UNITED STATES PATENT AND TRADEMARK OFFICE

APPLICATION NO.	FILING DATE	FIRST NAMED INVENTOR	ATTORNEY DOCKET NO.	CONFIRMATION NO.
10/685,309	10/14/2003	Philip Andrew Frank	005127.00467	9840

Office Action Summary

DETAILED ACTION

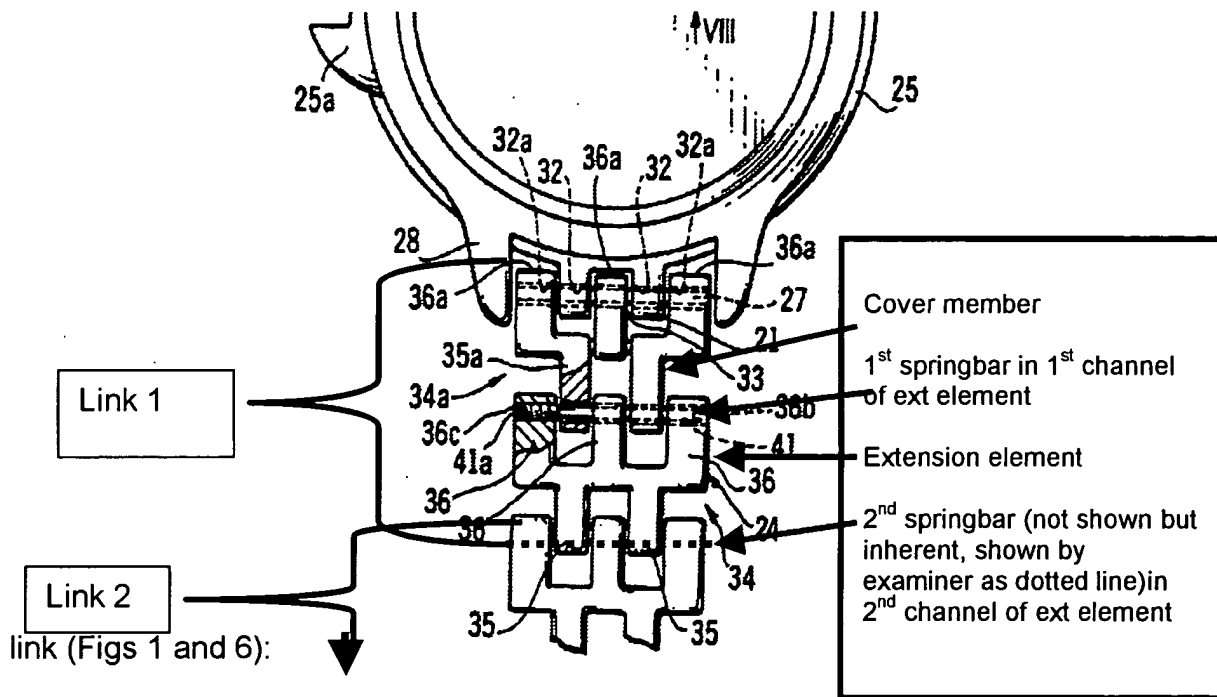
Re claim 29 and 46: Kikuchi teaches a wrist worn timepiece (inherent in watchband, as shown in Figure 1) comprising a case (1) defining a recess and a timing element positioned within the recess (annular middle 5 for movement of a watch to be mounted) (col 2 lines 40-43).

A band (4) extends from at least one side of the case (col 2 lines 62-64), the band having a plurality of links, each link having a cover member, an extension element, a 1st springbar extending through a first channel in the extension element to secure the extension element to the cover member, and a second springbar extending through a second channel in the extension element to joint the extension element to an adjacent

Note that col 4 line 32 specifically states that a pin, springbar, or screw are equivalent connectors. Note that the two channels are parallel

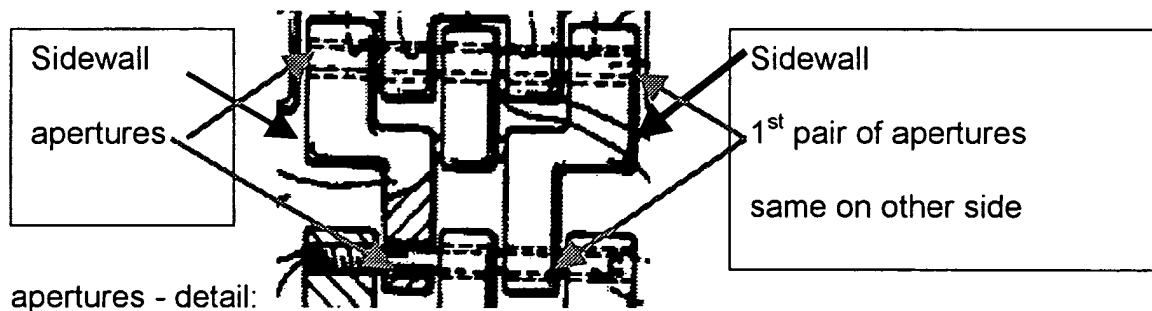
Re claim 35: the cover member (see Fig above) has a first pair of apertures that receive end portions of the first springbar to secure the extension element to the cover member (springbar shown as passing thru, and described in col 4 lines 22-33, with cover being called 34a and extension member being called 34). Note that col 4 line 32 specifically states that a pin, springbar, or screw are equivalent connectors.

Re 36: Figure 6 shown above shows the cover member with a primary surface (center top portion between the two bent sidewall portions) and a pair of sidewalls extending outward from primary surface, each sidewall defines one of the pair of

Re claims 37-38 - Fig 6 shows the joining to adjacent separate elements and cover member configured to join with end members of adjacent springbar.

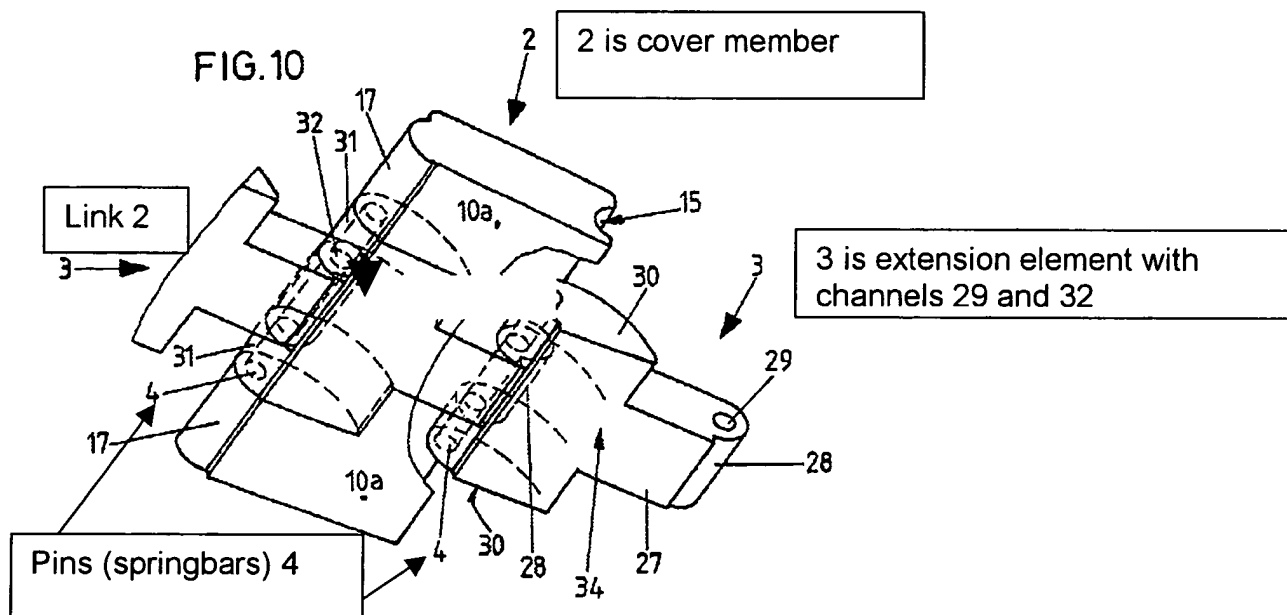
Re claims 29, 46: Delacretaz teaches a wrist worn timepiece (inherent in watchband, as shown in Figure 1) comprising a case defining a recess (Fig 1 and 6) and a timing element positioned within the recess (inherent in a functional watch of Fig 1 and 6). A band extends from at least one side of the case (Fig 1), the band having a plurality of links, (Fig 3) each link having a cover member (2), an extension element (3) (best seen assembled in Fig 10 and separate in Figs 7-9), a 1st springbar (4 - pin must inherently have some spring to function) extending through a first channel in the extension element to secure the extension element to the cover member, and a second springbar extending through a second channel in the extension element to joint the extension element to an adjacent link. Note the channels are parallel.

Re claims 37-38 - Fig 10 above shows the joining to adjacent separate elements and cover member configured to join with end members of adjacent springbar.

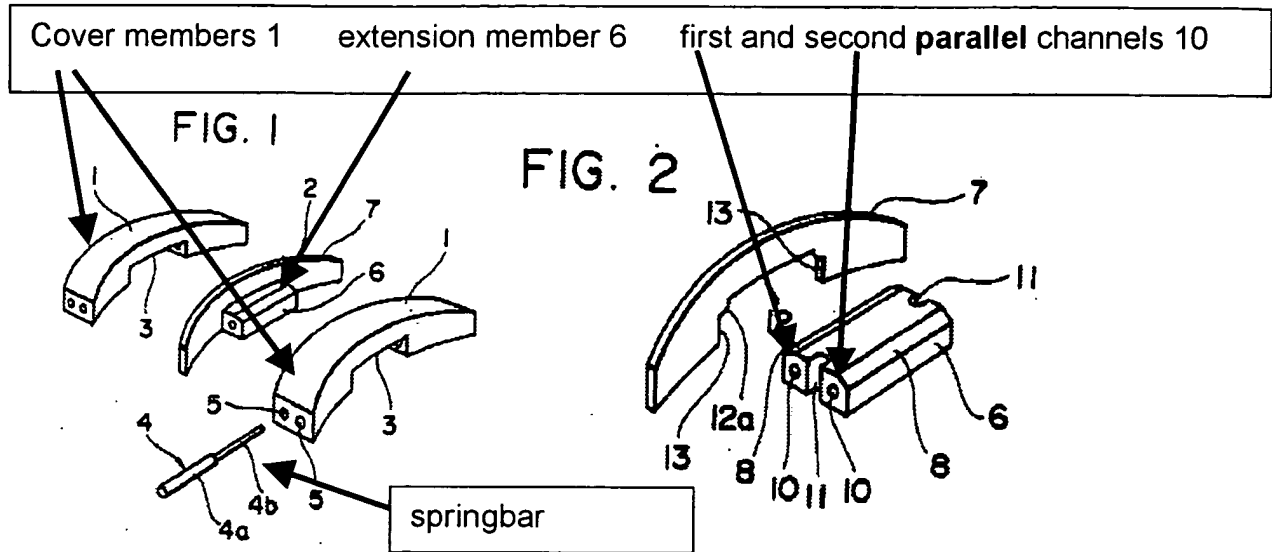
Re claims 29-30 and 42 and 46: Koenuma teaches a watch band with a plurality of links (col 1 lines 32-48) extending from at least one side of a case (15), each link including a cover member (1), an extension element (6) a 1st bar (4) extending thru a first channel (10) in the extension element to secure the extension element to the cover member, and a 2nd bar extending through a 2nd parallel channel in the extension element to join the extension element to an adjacent link. Examiner notes the broadest definition of channel does not require a through channel.

Re claims 32, 35-38 and 48: The Figures above from Koenuma show the springbars through the apertures and adjoining the extension element with the case or cover member. The sidewalls with apertures are best seen in Fig 1, also above.
